# SERVICE *No.884* BULLETIN

Date April 8, 1988 S/M

Lock Wiring of V-Band Couplings

SKETCH "A"

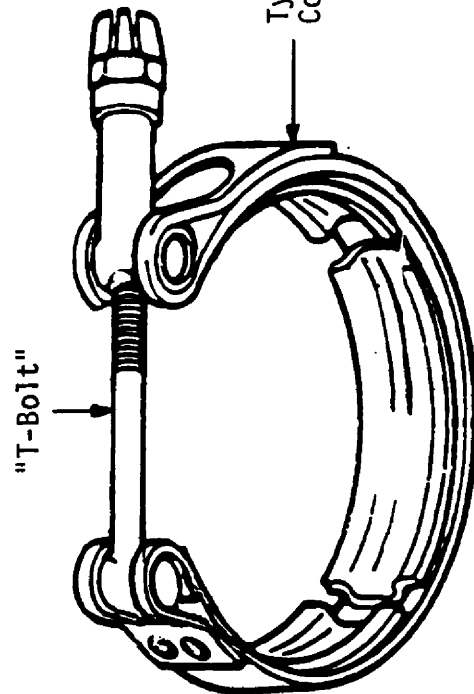
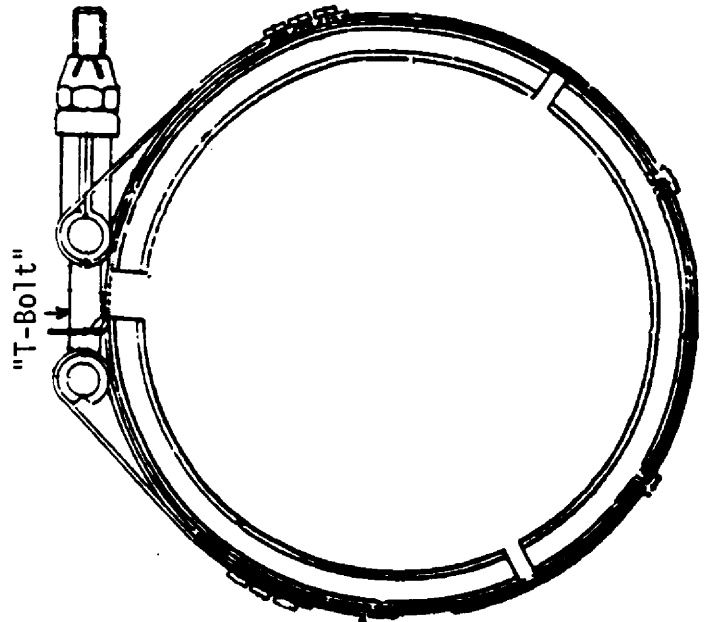
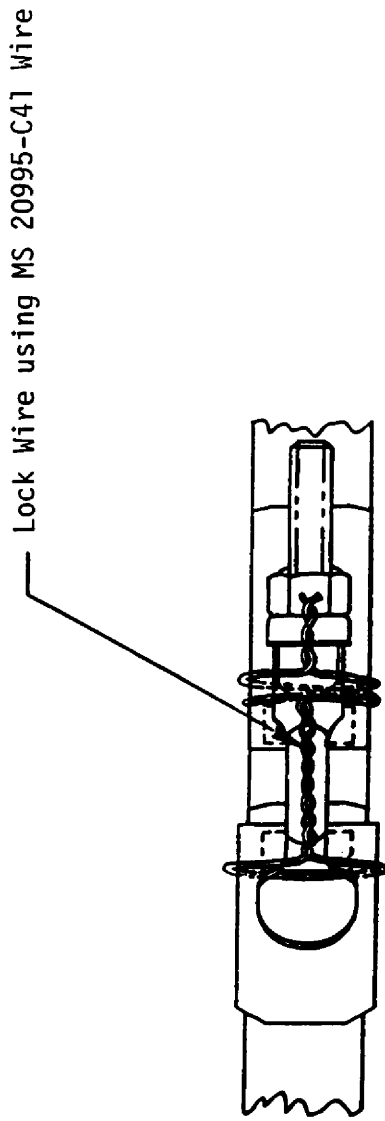
**PURPOSE:** Reports have been received of broken "T-bolts" in the V-Band Couplings used in the exhaust, bleed air and cabin heat systems on various Piper Airplanes. The failure of a T-bolt can allow the coupling to separate, permitting hot exhaust gases or bleed air to be expelled, creating a fire hazard.

This Service Bulletin provides an illustration and instructions for the inspection or installation of lock wire to the V-Band Couplings. Lock wiring of the V-Band Coupling will help prevent the above described condition, should failure of a "T-bolt" occur.

1. Refer to the applicable parts catalog to determine the number and location of V-Band Couplings on the affected aircraft.
2. Inspect all V-Band Couplings for security and integrity of T-bolts and lock wire (if installed). Refer to Sketch "A" attached.
3. If lock wire is damaged or missing, lock wire coupling using MS20995-C41 wire. Refer to Sketch "A".
4. Make an appropriate logbook entry of compliance with this Service Bulletin.

**MATERIAL REQUIRED:** MS20995-C41 Wire, As Required.
